Agenda – Council – December 13, 2017

Report – Standing Policy Committee on Property and Development, Heritage and Downtown Development – November 27, 2017

**Item No. 1 Subdivision and Rezoning – Southeast Ravenhurst/Pandora/CNR Rail Line/Perimeter Highway Boundaries (Transcona Ward)
File DASZ 10/2017 [c/r DCU 144031/2017D]**

SCHEDULE D

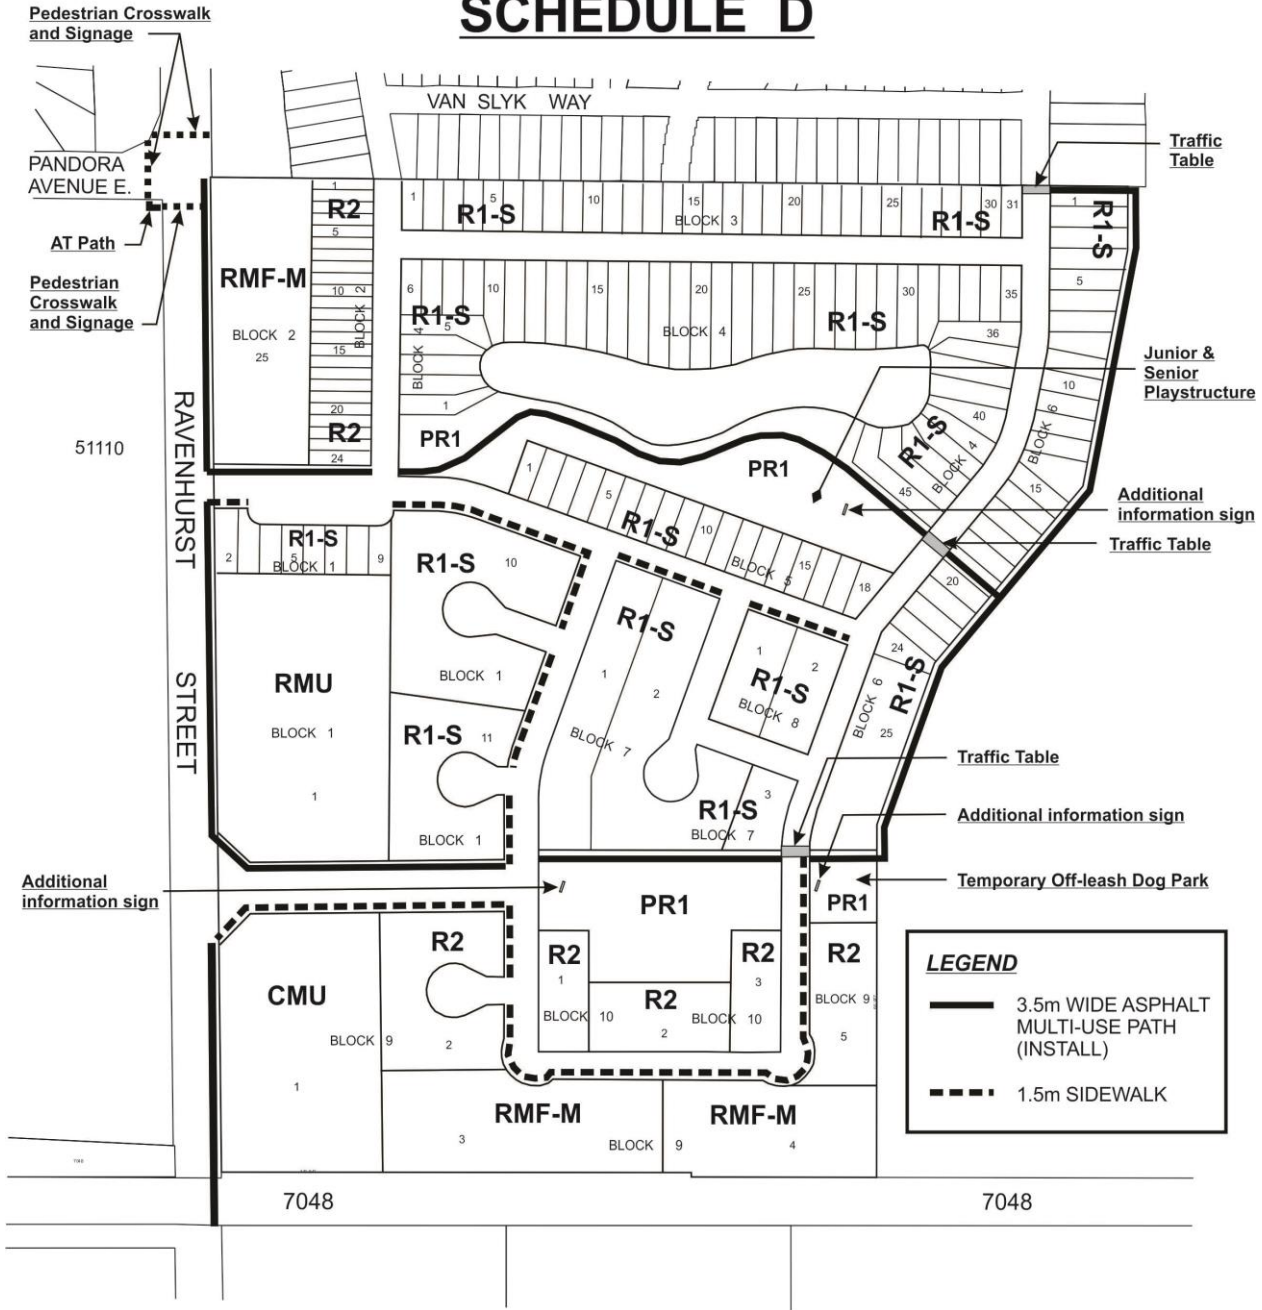
- Delete “and delete “2.4 m” and replace it with “3.5m”.” in recommendation 1.A.xxiii.
- Add the following new recommendation 1.A.xxvi.
 - “1.A.xxvi. That Schedule D be amended by replacing the 3.5m wide asphalt multi-use path in the park located south of Block 4 and north of Block 5, with a 2.4m wide asphalt path.”
